Access Compliance Report

Public Rights-of-Way

(Curb Ramps)

Intersection ID: 13736	Main Street: CAMDEN_RD	Cross Street: E_PARK_AV	Location: W
ADA ID: F714053E9795	Ramp Type: Perp	Initial Pass/Fail: Fail	Overall Compliance: No
Severity Score: 10			
Codes/Mitigation Info/Possible Solution		Field Measurements/Component Compliance

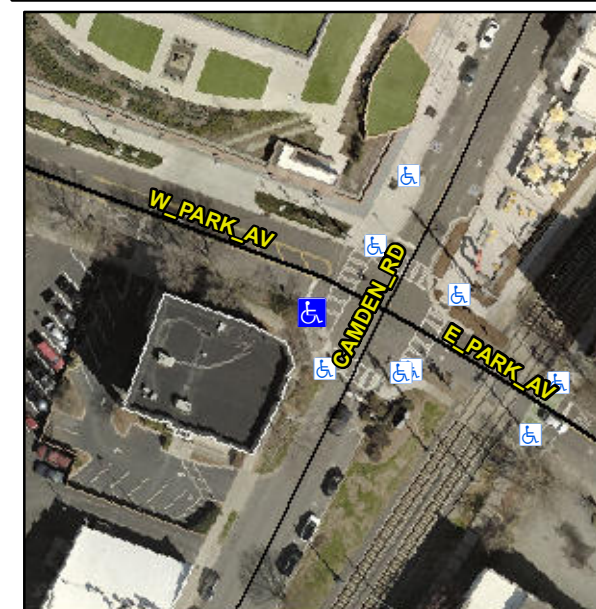
Not Found, R304.5.1

Compliance	Description	Data	Compliance	Description	Data
N/A	Ramp Length (in)	72.0	Yes	Ramp Slope (%)	8.0
No	Ramp Width (in)	47.0	Yes	Ramp XSlope (%)	3.6
N/A	Flare Type LT	N/A	N/A	Flare Type RT	N/A
N/A	Flare Slope LT (%)	N/A	N/A	Flare Slope RT (%)	N/A
N/A	Flare Traversable LT?	N/A	N/A	Flare Traversable RT?	N/A
N/A	Landing Length (in)	N/A	N/A	DWS Provided?	N/A
N/A	Landing Width (in)	N/A	N/A	DWS Contrast?	N/A
N/A	Landing Slope (%)	N/A	N/A	DWS Length (in)	N/A
N/A	Landing X Slope (%)	N/A	N/A	DWS Full Width?	N/A
N/A	Landing Curb? (Y/N)	N/A	N/A	DWS Offset (in)	N/A
N/A	Shared Landing?	N/A			
N/A	Gutter Ponding?	N/A	N/A	Gutter Slope (%)	N/A
N/A	Gutter Lip Ht (in)	N/A	N/A	Gutter X Slope (%)	N/A
N/A	Painted X Walk1?	Yes	N/A	Painted X Walk2?	N/A
	X Walk 1 Direction	To NE		X Walk 2 Direction	N/A
N/A	X Walk 1 Width (in)	105.0	N/A	X Walk 2 Width (in)	N/A
	X Walk 1 Slope (%)	3.2		X Walk 2 Slope (%)	N/A
	X Walk 1 X Slope (%)	4.2		X Walk 2 X Slope (%)	N/A

Remove & Replace Entire Ramp.
